The City of Spartanburg Design Review Board

AGENDA

First Baptist Church-250 E. Main Street

DRB-25-02000005

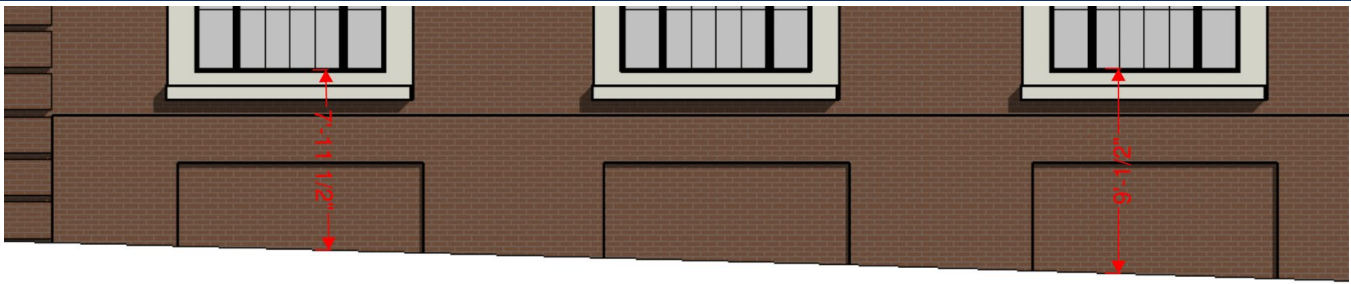
Ground Level Detailing of Transept along Dean Street Façade: There is a portion of the new transept along North Dean Street that does not have any windows or doors in excess of 60 feet. This condition is caused by a higher finished floor inside the church building relative to the sidewalk in that area and the desire to align the proposed windows along the same datum line as the existing windows. As a result, there is an area that appears to be at least 8 feet in height below the lowest point of the windows – hence the blank wall condition. While the window treatment is architecturally consistent with the main building, we do not have any specific design suggestions to resolve that condition, particularly because the sidewalk is already substandard and there is no room for ground level landscaping that would otherwise soften the transition.

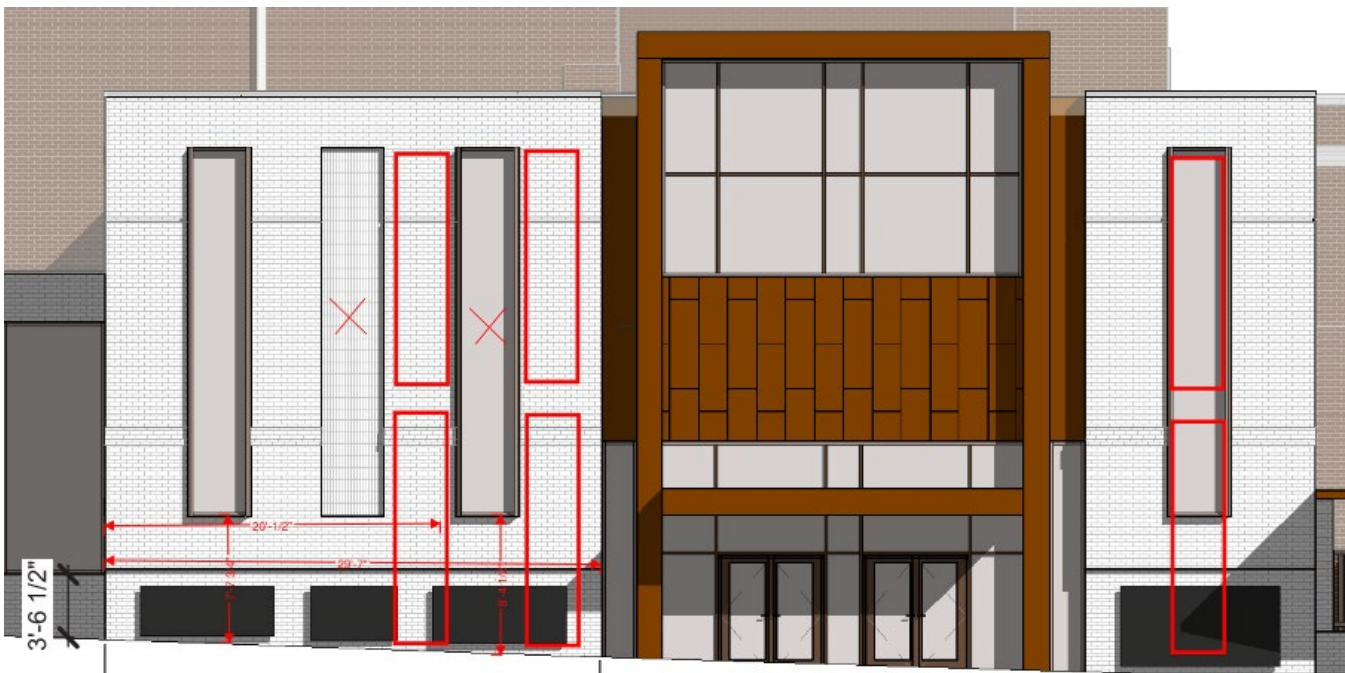
Ground Level Detailing of Entry Vestibule along Dean Street Façade: The proposed new entry vestibule along North Dean Street is also considered a blank wall condition because it does not have any windows or doors for a span of approximately 30 feet.

There is a portion of the new transept along North Dean Street that does not have any windows or doors in excess of 60 feet. At present, there are three openings shown. The one to the left appears to go into spaces that is at the same finished floor level as the church. The middle one appears to be an elevator shaft. The one to the right (north) in the image below appears to open into space at the finished floor of the church as well as the entry vestibule. It appears to be possible to insert an asymmetrical pattern of windows that can extend to the sidewalk level and satisfy the transparency requirement (see suggestion below). We recommend a similar treatment on the other side of the entry as well. There are, of course, other options that could be considered for windows at the ground level.

- **6.4.4.a Minimize Blank Walls & 6.4.4.c.2 Transparency Zone:** To permit in excess of 20 feet of building wall that lacks transparent windows or doors not exceeding maximum four (4) feet in height above the sidewalk grade along North Dean Street and to have less than 60% of total frontage in ground-level transparent glazing. [Note the alternative for the entry vestibule wall]
- **8.1 Required Streetscape:** To permit a portion of Dean Street to remain non-compliant with only an 8 foot sidewalk (no street trees).
